D3016-041 SEAT FRAME ASSEMBLY

DRAWING NO. D3016	TITLE SEAT FRAME ASSEMBLY	REV. A	DART AEROSPACE LTD ENGINEERING ORDER	D.E.O. NO. D3016-A-1	SHEET NO. SHEET 1 OF 1	SCALE NTS
DRAWN 1	CHECKED UP	MFG. APPR. RE	APPROVED WAP	DE APPR. WAP		
DATE 10.01.29	DATE 10.01.29	DATE 10.01.29	DATE 10.01.29	DATE 10.01.29	DATE 10.01.29

TO REVISE D3016-11 SADDLE'S HOLE SIZES

D3016-11 SADDLE

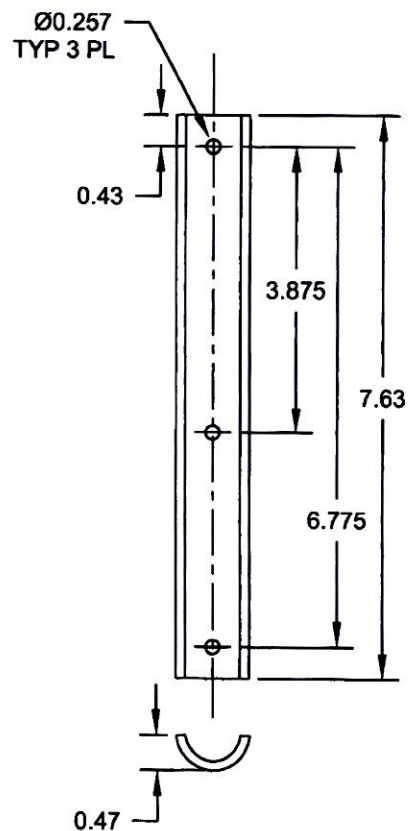
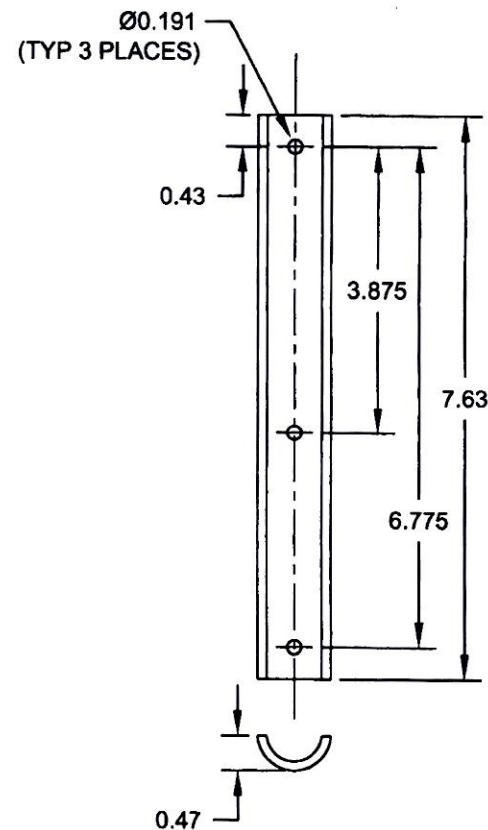
DETAIL D3016-11 SADDLE (SHEET 3): Ø0.257 TYP 3 PL WAS Ø0.191 (TYP 3 PLACES) AS SHOWN:
